Access Compliance Report

Public Rights-of-Way

Intersection ID: 14482	Main Street: WALLACE_AV	Cross Street: WALLACE_GLEN_DR	Location: SE
ADA ID: 0C8D0E2A089D	Ramp Type: BlendTrans1	Initial Pass/Fail: Fail	Overall Compliance: No
		Severity Score: 17.5

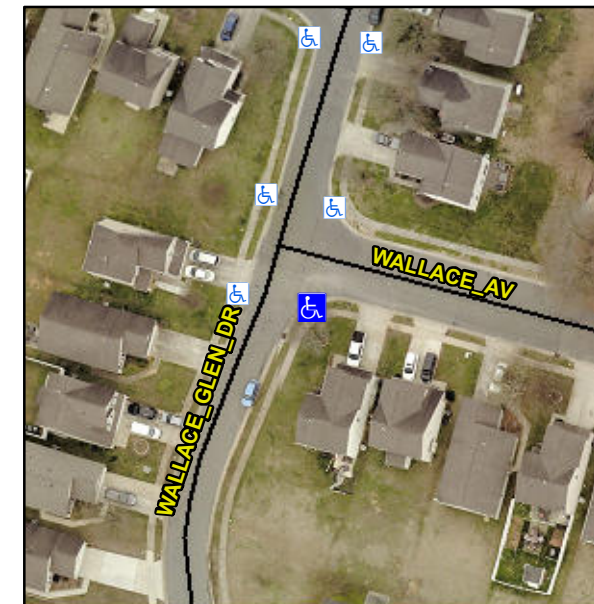
Not Found, R304.5.1

Compliance	Description	Data	Compliance	Description	Data
N/A	Ramp Length (in)	49.0	Yes	BlendTrans Slope (%)	3.2
No	Ramp Width (in)	34.0	Yes	BlendTrans XSlope (%)	1.0
N/A	Flare Type LT	N/A	N/A	Flare Type RT	N/A
N/A	Flare Slope LT (%)	N/A	N/A	Flare Slope RT (%)	N/A
N/A	Flare Traversable LT?	N/A	N/A	Flare Traversable RT?	N/A
N/A	Landing Length (in)	N/A	N/A	DWS Provided?	N/A
N/A	Landing Width (in)	N/A	N/A	DWS Contrast?	N/A
N/A	Landing Slope (%)	N/A	N/A	DWS Length (in)	N/A
N/A	Landing X Slope (%)	N/A	N/A	DWS Full Width?	N/A
N/A	Landing Curb? (Y/N)	N/A	N/A	DWS Offset (in)	N/A
N/A	Shared Landing?	N/A			
N/A	Gutter Ponding?	N/A	N/A	Gutter Slope (%)	N/A
N/A	Gutter Lip Ht (in)	N/A	N/A	Gutter X Slope (%)	N/A
N/A	Painted X Walk1?	No	N/A	Painted X Walk2?	No
	X Walk 1 Direction	To NE		X Walk 2 Direction	To NW
	X Walk 1 Width (in)	N/A		X Walk 2 Width (in)	N/A
	X Walk 1 Slope (%)	0.2		X Walk 2 Slope (%)	1.5
	X Walk 1 X Slope (%)	1.7		X Walk 2 X Slope (%)	0.2

N/A	Ramp inside XWalk1?	N/A	N/A	Ramp inside XWalk2?	N/A
	Road Slope (%)	0.5		Clear Space?	N/A
	Road X Slope (%)	2.9	N/A	Clear Space to XWalk (in)	N/A
N/A	Any Obstructions?	N/A	N/A	Storm Grate/Utility Hazard?	N/A
	Obstruction Type			Storm Grate/Utility Type	
		N/A			N/A
			Yes	Surface Condition? (G/P)	Good
			No	Curb Slope (%)	8.4

Remove & Replace Curb Ramp With Two New Directional Ramps or Equivalent.
